Informal document GRSP-58-06-Rev.1
(58th GRSP, 7-11 December 2015,
agenda item 20)

Proposal for Supplement 7 to the 06 series of amendments to Regulation No. 14 and Supplement 7 to the 06 series of amendments to Regulation No. 16

Submitted by the expert from the Netherlands

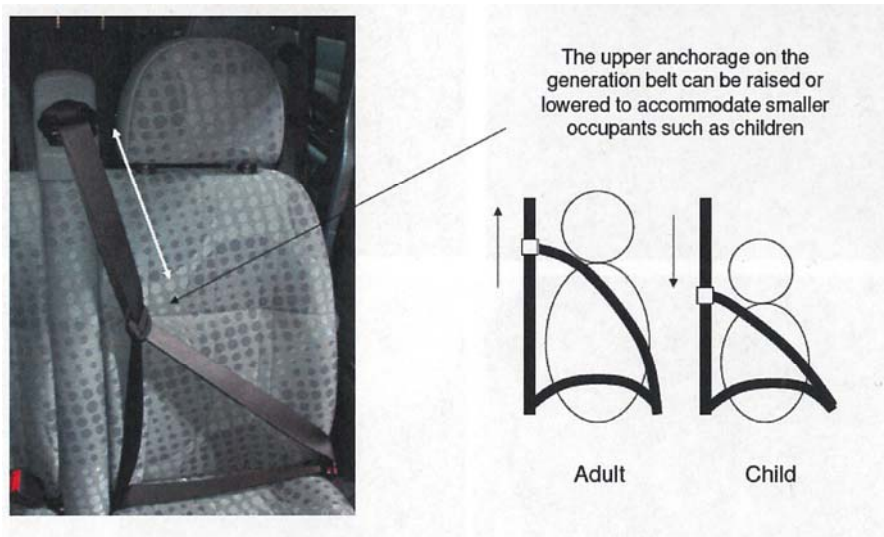
2. The situation explained above has caused confusion so far: a belt/restraint system that makes use of a **flexible shoulder adjustment device for height** (sometimes called **generation belt**, see the explaining figure on next page), does not make use of the upper-pillar loop for adjustment and therefore cannot be mentioned on the Communication form.

4. This proposal introduces a definition for flexible shoulder adjustment device for height. This definition has been further extended to make sure that the adjusting forces may NOT be derived from the lap belt part (examples of options which should not be covered in our definition, because they enlarge the danger of submarining, are given next page). The definition is worded in the positive way, so what is preferred.

5. Moreover, the complexity and sensibility of the flexible adjustment device for height (generation belts) does not justify a dynamic test according to UN Regulation No. 16, which provides a generic stiff seat. A test proposal for a restraint system (in combination with a real vehicle seat) is shown below:
